# *Contessa Unit 2*

## **ADDENDUM #1**

05/21/2026

Project Name:           CONTESSA UNIT 2

**C38**  
 CUDEENGINEERS.COM

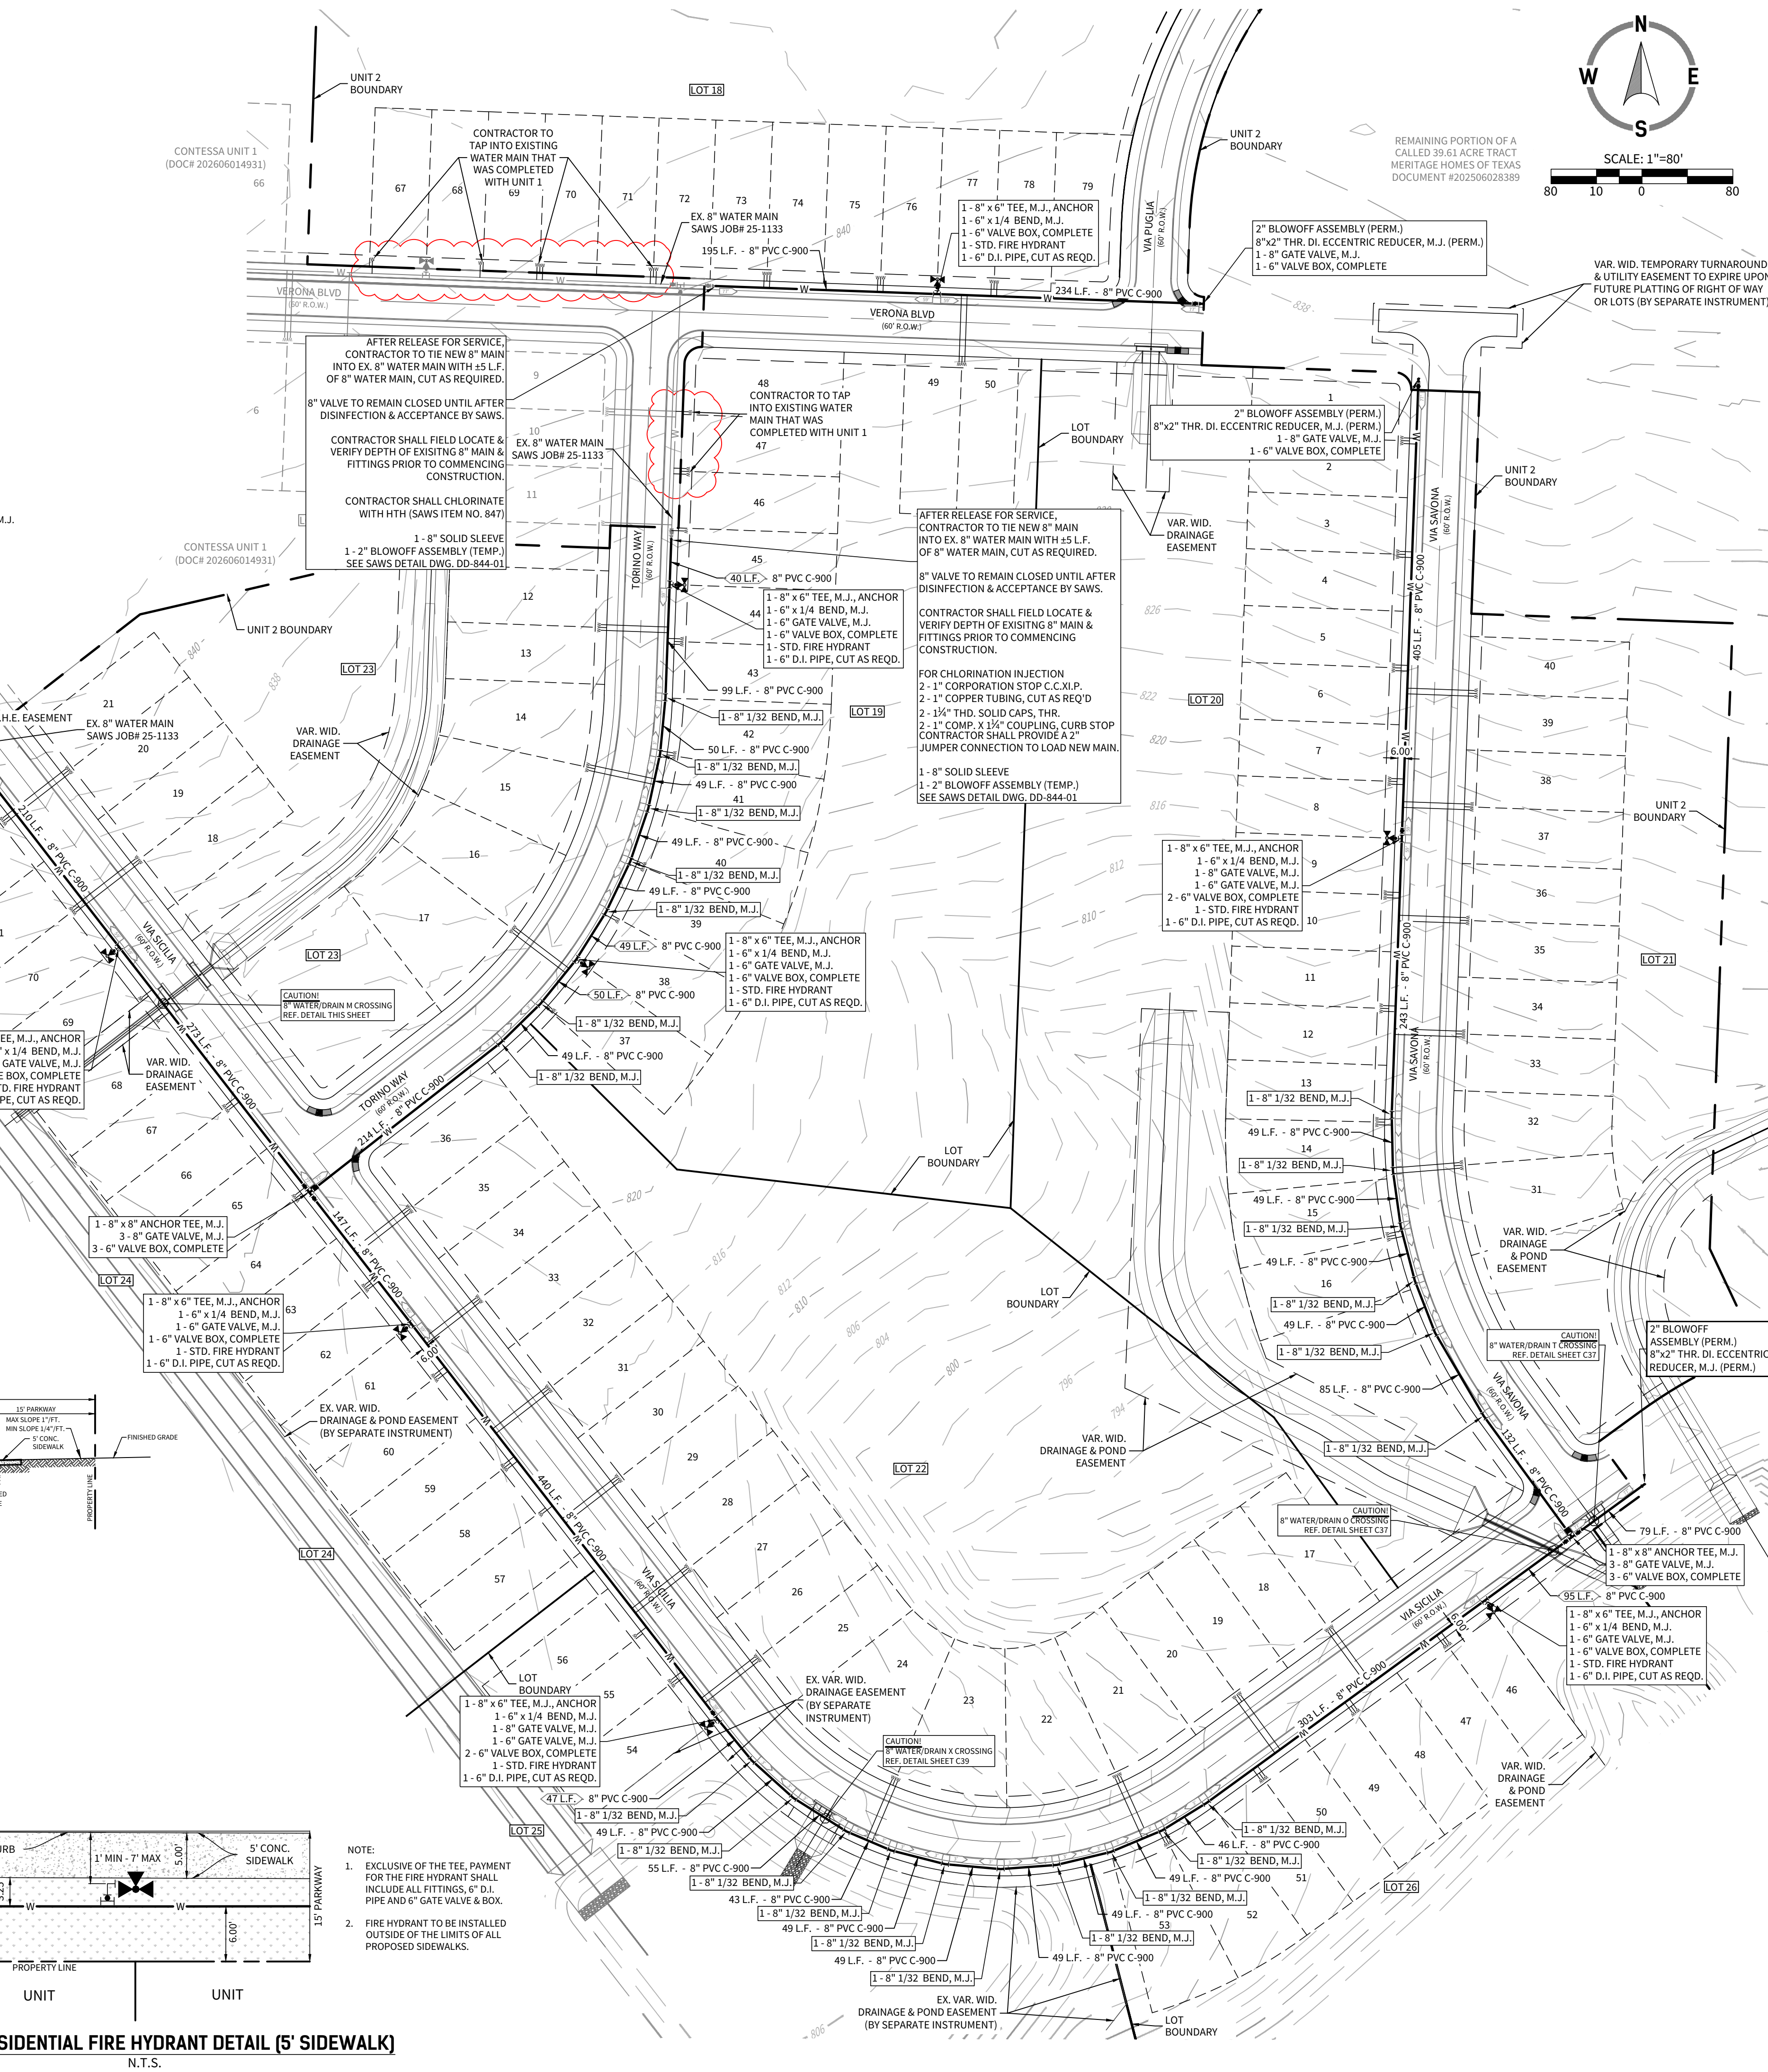
- 1. Pre-Bid Meeting Agenda .....3 pages
- 2. Pre-Bid Sign-in Sheet.....2 pages
- 3. Bidder Questions and Answers .....3 pages
- 4. Revised Bid Form .....6 pages
- 5. Revised Drawings .....2 pages
  - a. C37 & 38 ONSITE WATER DISTRIBUTION PLAN – ADDED TWO MORE GATE VALVES
- 6. Conduit Plan .....2 pages
- 7. CAD Topo ..... under separate cover
